BROKEN HILL CITY COUNCIL REPORT NO. 34/18

SUBJECT: DEVELOPMENT APPLICATION 156/2017. PROPOSED STATUE OF ROY INWOOD VC ON THE FOOTPATH IN FRONT OF 403 ARGENT STREET, BROKEN HILL

Photo mock-up of statue at front of premises (supplied by applicant)

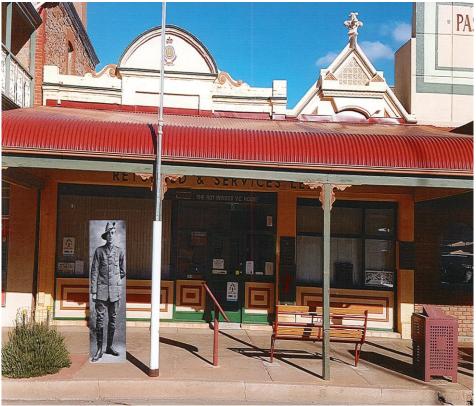
The proposed bronze sculpture is of value to the heritage of this town and a very worthwhile subject matter to portray. I am in agreement that the sculpture should be made but would suggest that the location is reconsidered for the following reasons:

- The location does not do the sculpture justice.
- There are a number of cluttered items on that part of the footpath including, a bush, bench, bin and 2 different didactic panels which do not explain the sculpture. None of these items do the sculpture justice or award it due respect.
- The didactic panel that will be directly next to the sculpture is about Argent St in 1887 and gives a confusing message to the public.
- If the sculpture is too close to the road cars may come close to it.
- When cars park or stop at the intersection in front of the RSL building the sculpture will be visually blocked.
- Is there enough safe space around the sculpture for the public to safely photograph it and admire it without getting too close to the road or blocking access?
- What will happen if the RSL moves location?

- Locating an isolated statue in the street in a location that has no specific meaning except that it is outside the RSL building does not seem like a sound approach to public art.

- The location is already busy and cluttered and without a major rework the statue will present as an obstruction, no matter how much artistic merit it may have.

Support is given to the proposed erection of a statue of Roy Inwood VC, however not in the location proposed. It is considered to be of more benefit to the public to be located elsewhere, perhaps the existing war memorial remembrance area at the front of the Court House or even the Town Square. These alternative locations would do the statue the justice it deserves.
